# Service Bulletin

Bulletin No.: 20-NA-225

**Subject: Low Battery Charge After Vehicle Sits for Short Period of Time**

Brand:	Model:	Model Year:		VIN:		Engine:	Transmission:
		from	to	from	to		
Chevrolet	Express	2021	2021			L8T	
GMC	Savana

5694188

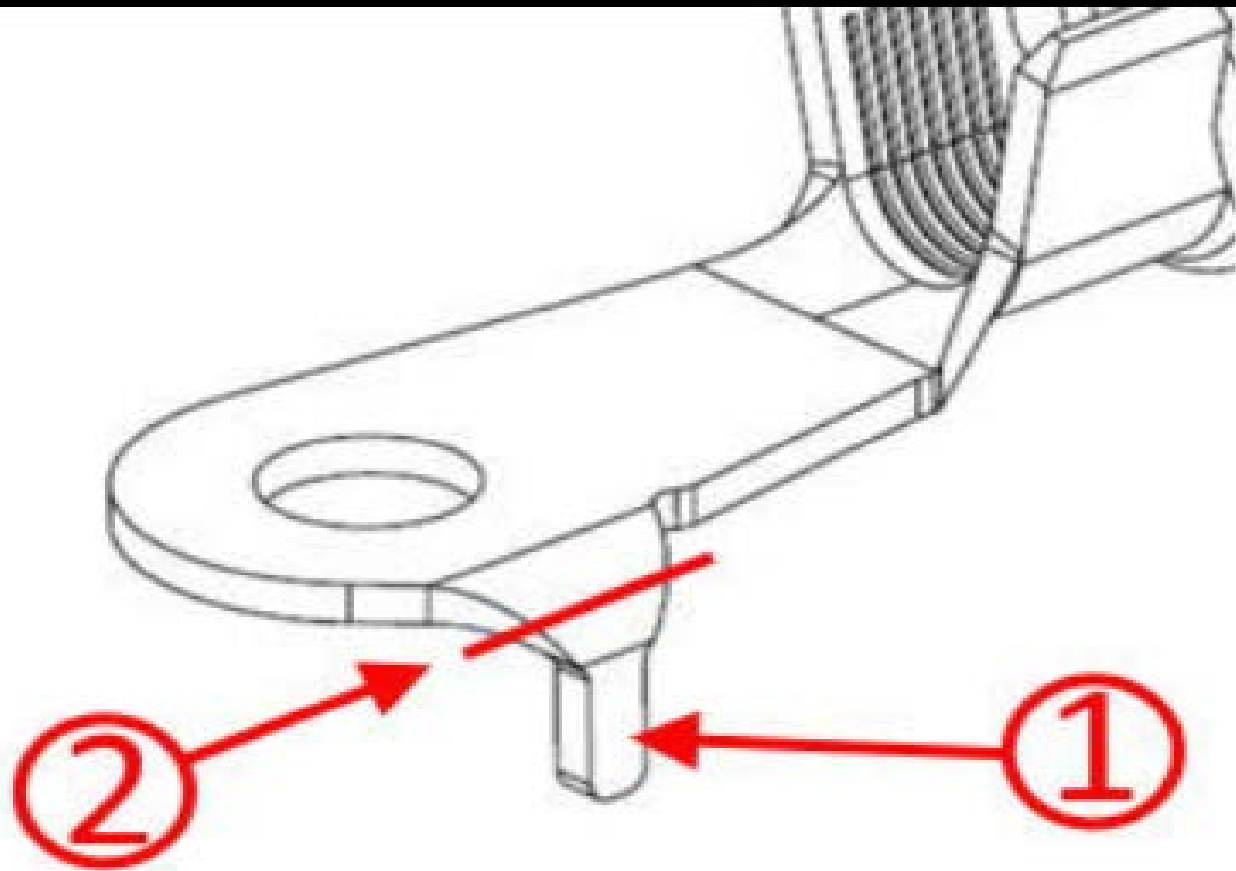
<b>Involved Region or Country</b>	North America, Israel
<b>Condition</b>	Some customers may comment on a low battery charge after sitting for a short period of time.
<b>Cause</b>	<p>This condition may be caused by a voltage draw.</p>  <p style="text-align: right;">5693951</p> <p>– The anti-rotation tabs on the positive side cables, located at the mega fuse, may contact the mega fuse mounting stud nuts.</p>
<b>Correction</b>	Trim the anti-rotation tabs on the positive battery cables located at Mega fuse.

2. Remove the Mega fuse cover (3).
3. Remove the fasteners that secure the pre (2) and post (1) positive cables to the fuse.

4. Starting from the bottom of the anti rotation tab (1), measure up approximately 2mm (2) as shown in the graphic above.

5. Utilizing cutters, cut the tabs from the cables.

**Note:** Only cut enough of the tab so that it does not contact the stud or the fastener as shown in the graphic above.

**Important: DO NOT** cut the all the anti rotation tab flush, as shown in the graphic above. Cutting the tab flush may cause the cables to rotate and contact the fasteners or the Mega fuse mounting studs.
